## SERVICE ADVISORY # 17-286

### Impact Rear A/C Wiring

It has been determined that on some 2017-2018 Impact models the air conditioner was wired incorrectly preventing the compressor from running. This advisory explains how to correct the problem if it exists.

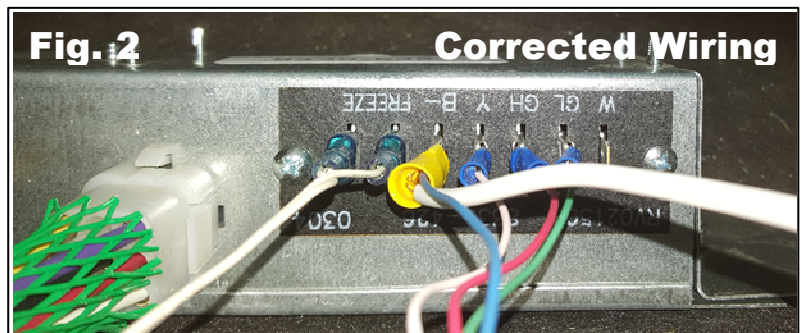
Locate the rear A/C control box, Figure 1. The wiring must be corrected as follows.

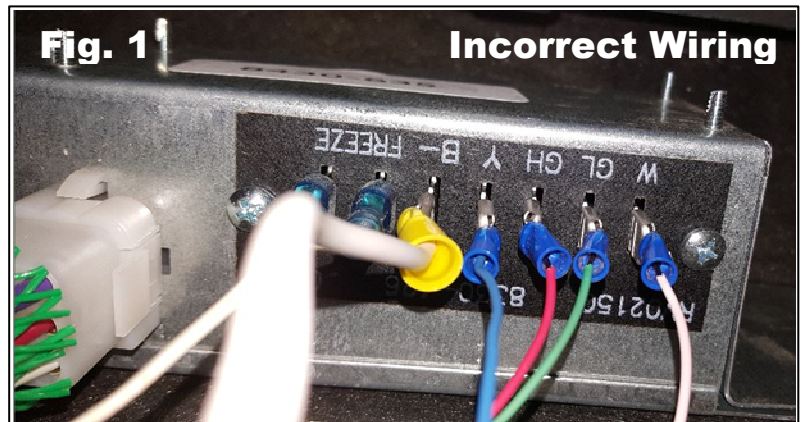
1. Remove **blue** wire from terminal “Y” and attach it to the white wire on the “B-” using a 12-gauge spade connector.
2. Move **white** wire from terminal “W” to “Y”. There will be nothing attached to the “W” terminal. See Figure 2.

Remove the white wire on terminal “B-” and the blue wire on terminal “Y”. Cut the existing spade connectors off each wire and attach them together using a 12-gauge spade connector. Install new connector on terminal “B-”.

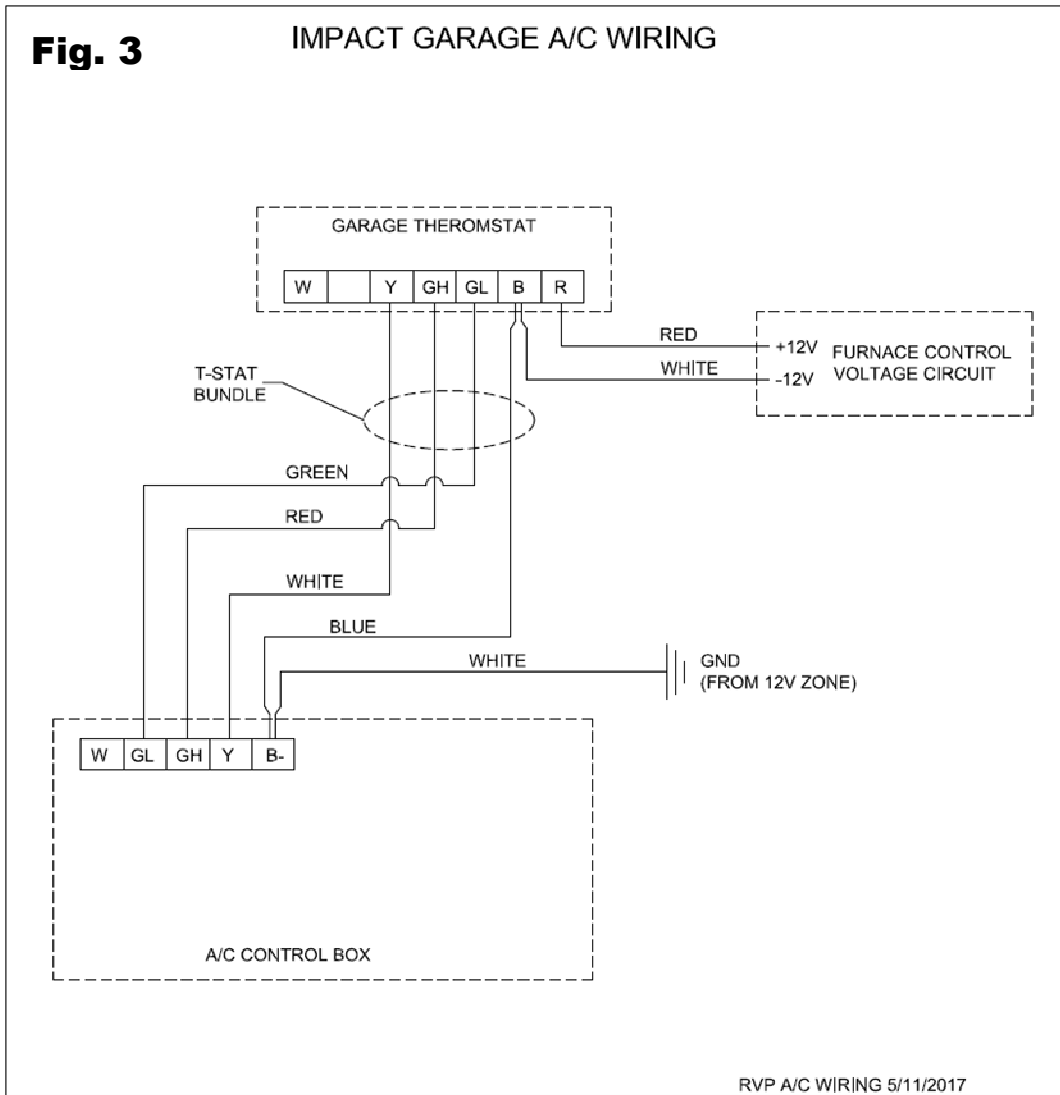
Remove the white wire attached to terminal “W” and move it to the “Y” terminal. See wiring diagram in Figure 3.
